GFA AD 340

## AIRWORTHINESS DIRECTIVE

Wing tip fore/aft freeplay allowance.

B U L L E T I N No BR-032/87 "JANTAR"

Fig.2.

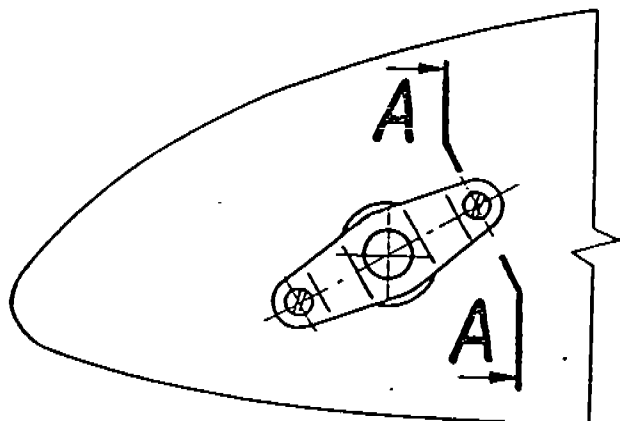
5.3. On the places where the compensation is required /the pivots concerned/ the proper special washer /Fig.1/ should be assembled and if necessary the additional washer added /Fig.2/ so that :

blacha, metal-sheet, Blech,  
пластинка:  $\pm 0,2; 0,4; 0,6$  mm.  
w gat., sort, Sorte, сорт (20-N)

Fig.3.

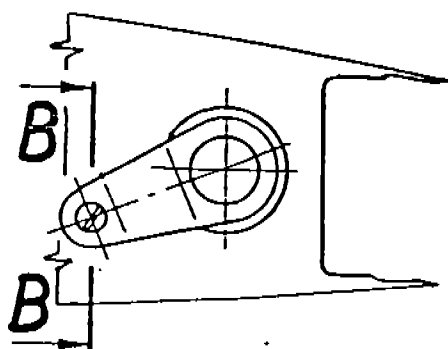
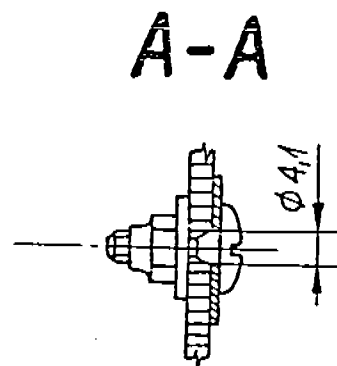
On the places /found by means of measurements/ where the "excessive" plays appear the special compensating washer /one or both sides faced with or without the additional ring washer depending on location and value of a play/ should be fixed by means of screws /or screws for metal sheet/. The way of location the washer in respect to the pivot is shown on Fig.3.

5.3.1. In case of only glass-fibre wall of the proper thickness, the compensating washer should be fixed by means of the screws with washer and nut /Fig.3, version a/.

5.3.2. In case of plywood rib or glass-fibre rib with wooden block the compensating washer should be fixed by means of screws for metal-sheet /Fig.3, version b/.
